Work Order ID 70051

Item Name: Crosstube Turning Detail

DART AEROSPACE LTD	Work Order:	70051
Description: Crosstube Assembly	Part Number:	D407-667-245
Inspection Dwg: D407-667-245 Rev: F		Page 1 of 1

DRAWING NO. D407-667-245	TITLE CROSSTUBE ASSY (407 HIGH AFT)	REV. F	DART AEROSPACE LTD ENGINEERING ORDER		D.E.O. NO. D407-667-245-F-1	SHEET NO. SHEET 1 OF 2	SCALE NTS
DRAWN <i>[Signature]</i>	CHECKED <i>[Signature]</i>	MFG. APPR. <i>[Signature]</i>	APPROVED <i>[Signature]</i>		DE APPR. <i>[Signature]</i>		
DATE 11.04.08	DATE 11.04.12	DATE 11.04.12	DATE 11.04.12		DATE 11.04.12

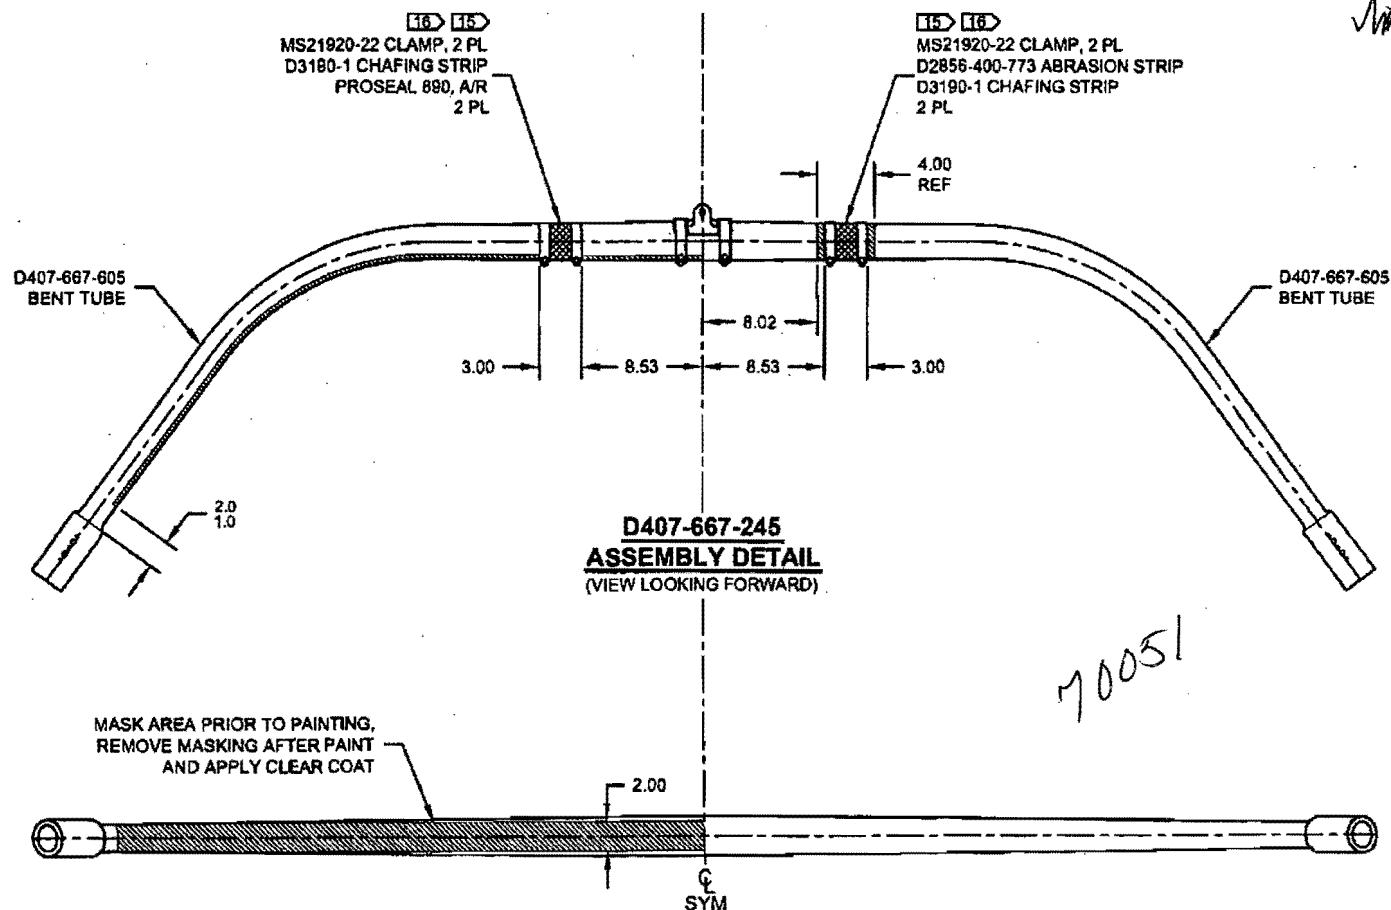
PURPOSE:

REMOVED ABRASION STRIP IN FAVOR OF A THIN LAYER OF PROSEAL 890.

NOTES 2 AND 15, SHEET 1 ARE AMENDED AS FOLLOWS:

- 2) FINISH: CHEMICAL CONVERSION COAT PER DART QSI 005 4.1
PRIME INSIDE AND OUTSIDE PER DART QSI 005 4.2
MASK UNDERSIDE OF CROSSTUBE AS SHOWN (HATCHED AREA) AND
PAINT OUTSIDE PER DART QSI 005 4.2
REMOVE MASKING AND APPLY CLEAR COAT
- 15) APPLY A THIN COAT OF PROSEAL 890 ON INSIDE CONCAVE SURFACE OF D3190-1
CHAFING SHIELDS AND LET CURE PER MANUFACTURER'S INSTRUCTIONS. INSTALL
PROSEALED D3190-1 CHAFING SHIELDS ONTO CROSSTUBE BY APPLYING A THIN COAT
OF PROSEAL 890 ONTO CROSSTUBE. BE SURE TO ELIMINATE ANY AIR GAPS.

- 2) FINISH: CHEMICAL CONVERSION COAT PER DART QSI 005 4.1
PRIME INSIDE AND OUTSIDE PER DART QSI 005 4.2
PAINT OUTSIDE PER DART QSI 005 4.2
- 15) INSTALL D2856-400-773 ABRASION STRIP WITH A 0.13 REF GAP ON BOTTOM SIDE OF
CROSSTUBE PER QSI 035.
